# **New Beauly Area 400kV Substation and HVDC Converter Station Report on Consultation**

November 2023

Figure 2 – Beauly Area Proposed 400kV Substation and HVDC Converter Station Site

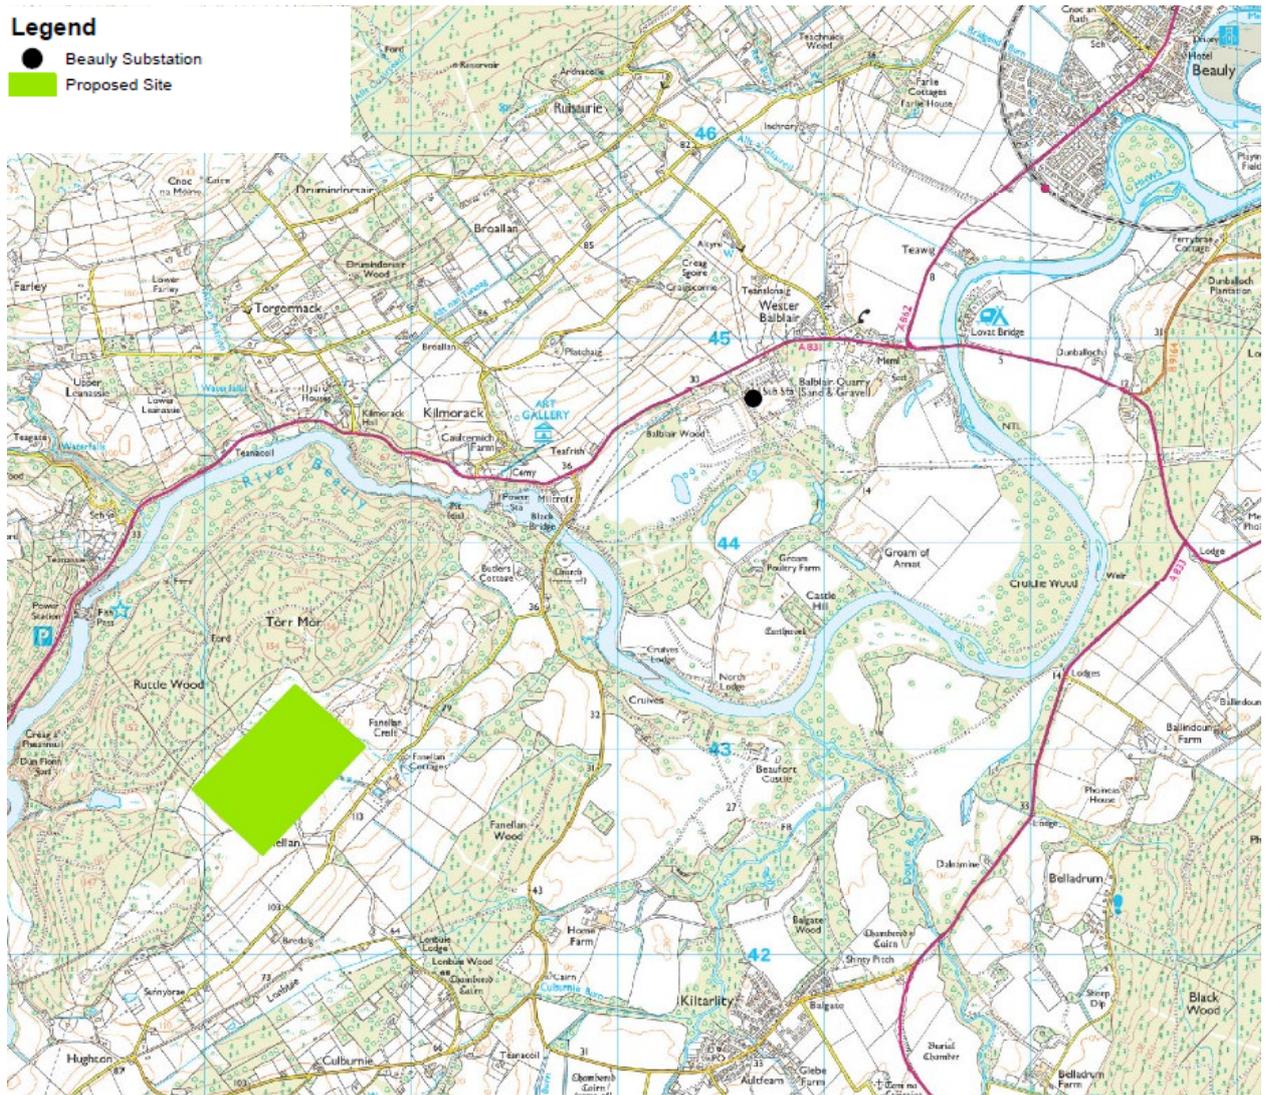
We now plan to further develop the Option 7 (combined) option as part of our Planning Application due for submission next year. We will review and implement, where feasible, The Highland Council's recommendations which are to reduce land take, look at lowering the platform level, consider the use of GIS and involve a landscape architect to ensure that the design integrates with the existing landform during the design development phase of Option 7. Please see Figure 2 for reference.
